2/3/03	Revised Driveway and Added Curb Ramp Elevations
DATE	REVISION
STATE OF HAWAII DEPARTMENT OF TRANSPORTATION HIGHWAYS DIVISION PAVEMENT GRADING PLAN KANEOHE BAY DRIVE IMPROVEMENTS <i>Vicinity of Puohala Street to Kawa Bridge</i> <i>Federal Aid Project No. STP-065-1(9)</i> Scale: 1"=20' Date: June, 2002	
SHEET No. 2 OF 3 SHEETS

PAVEMENT GRADING PLAN

KANEOHE BAY DRIVE IMPROVEMENTS
Vicinity of Puohala Street to Kawa Bridge
Federal Aid Project No. STP-065-1(9)

ADD. 34

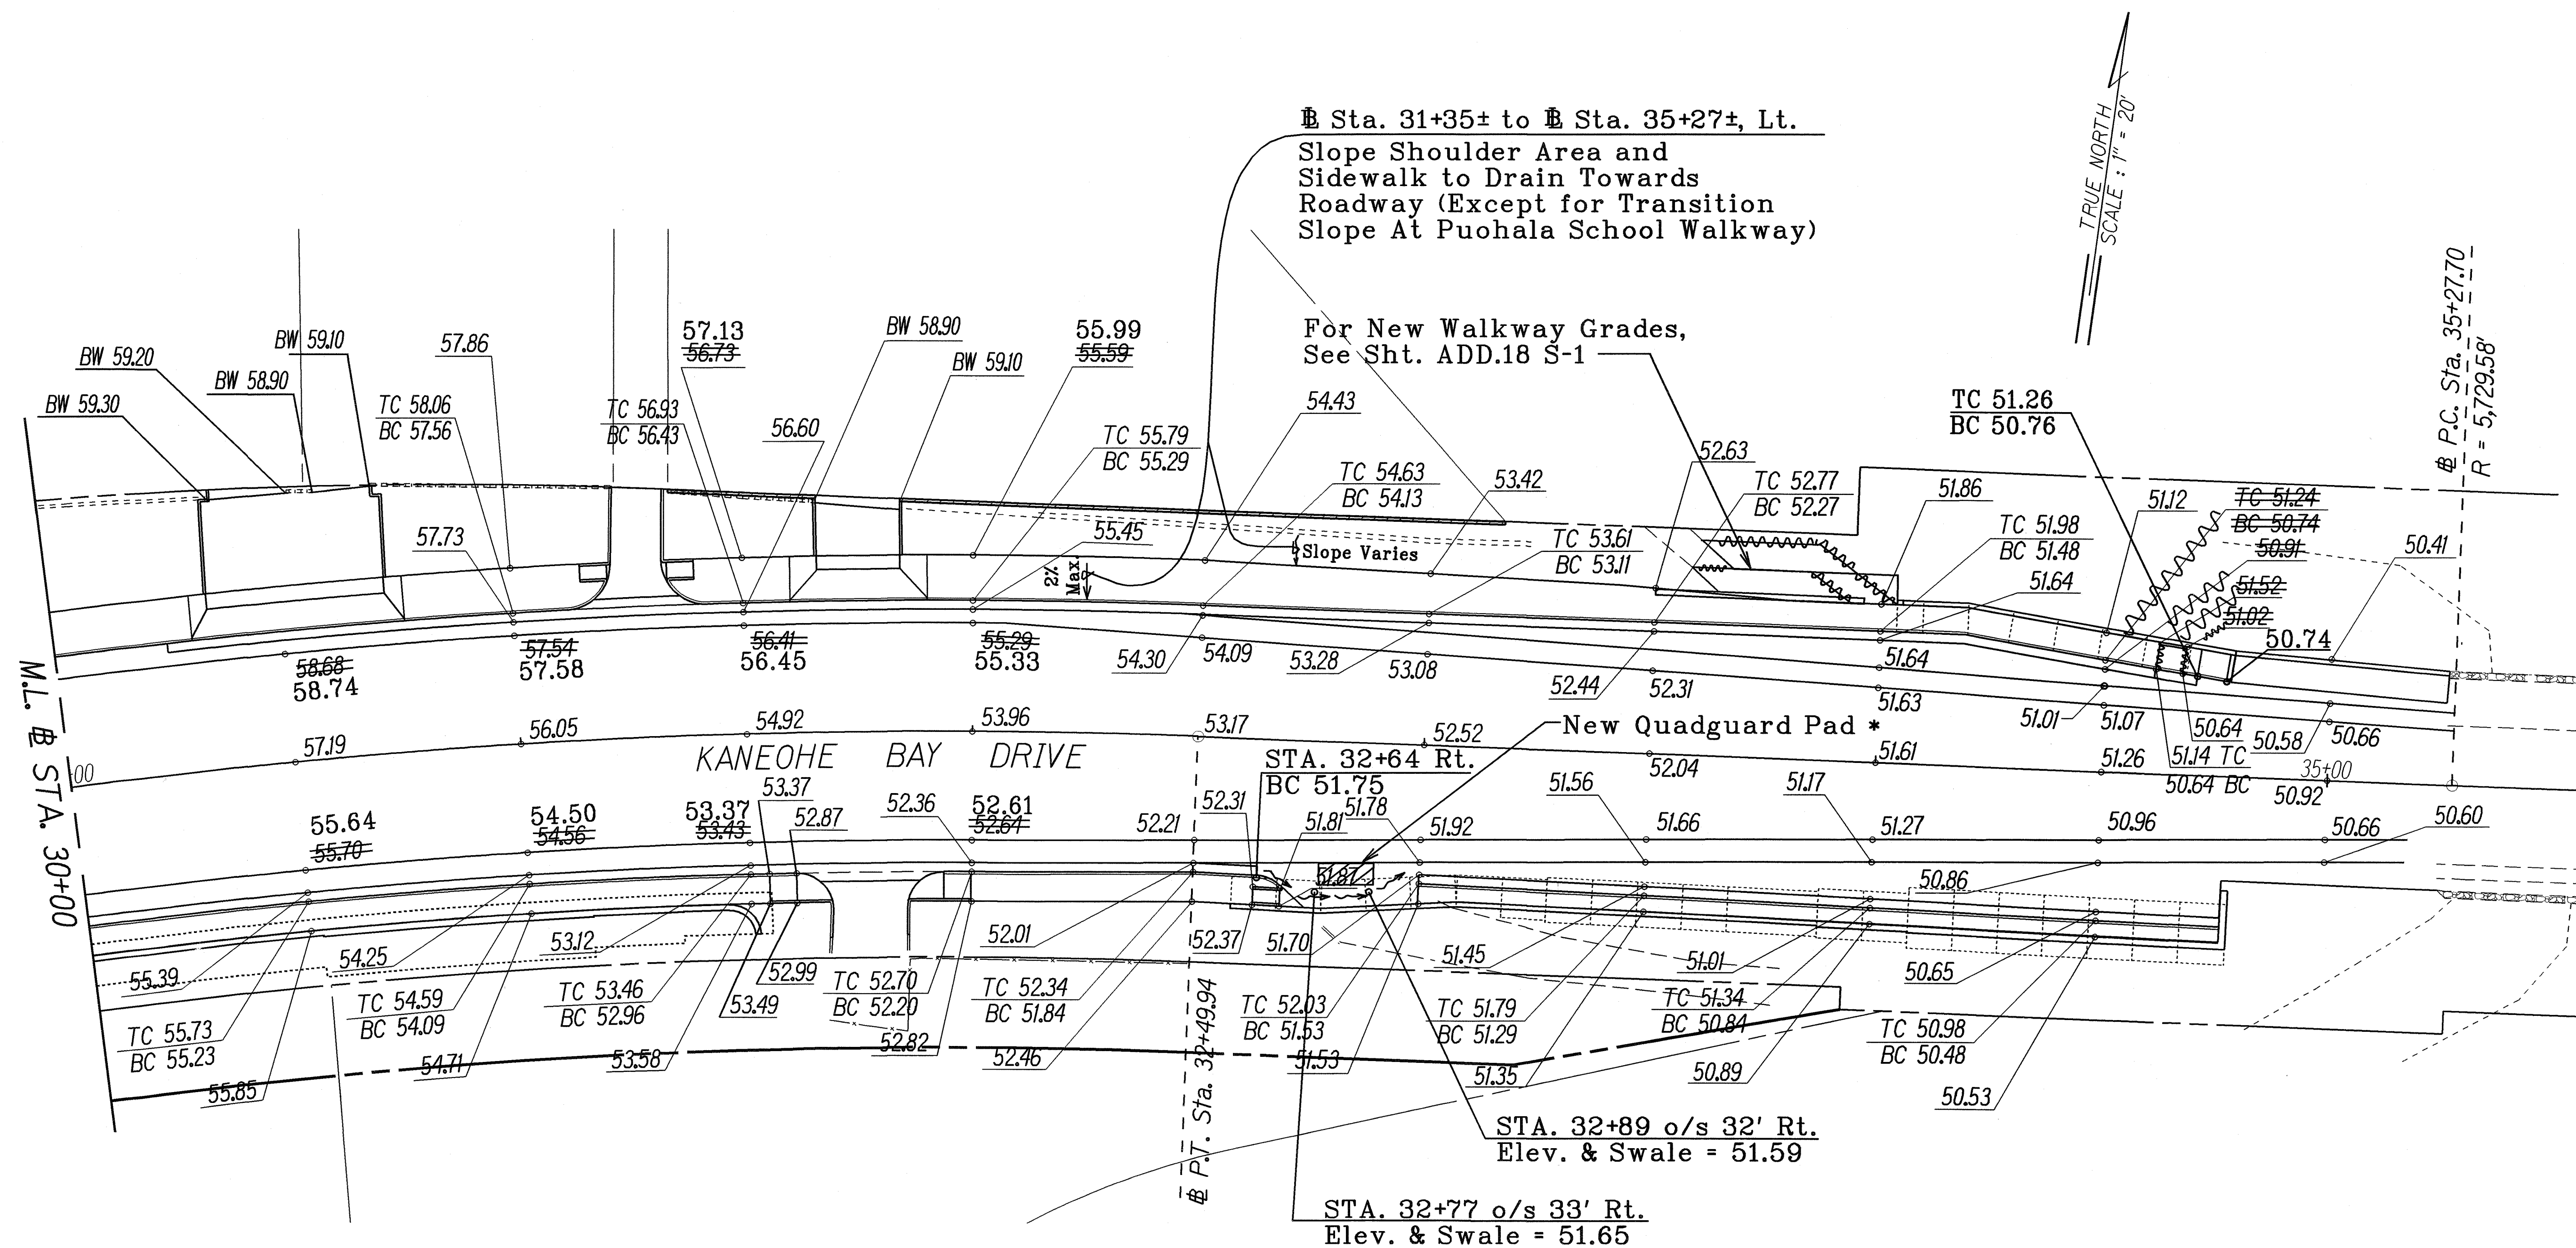
2/3/03 Revised Driveway Per Addendum No. 1

* New Quadguard Pad
Sta. 32+77 to Sta. 32+89 o/s 27', Rt.

Route New AC Swale to Drain Around Quadguard Pad. Warp Pavement to Match Adjacent Gutter and Shoulder Grades At Sta. 32+64 Rt. & Sta. 33+00 Rt.
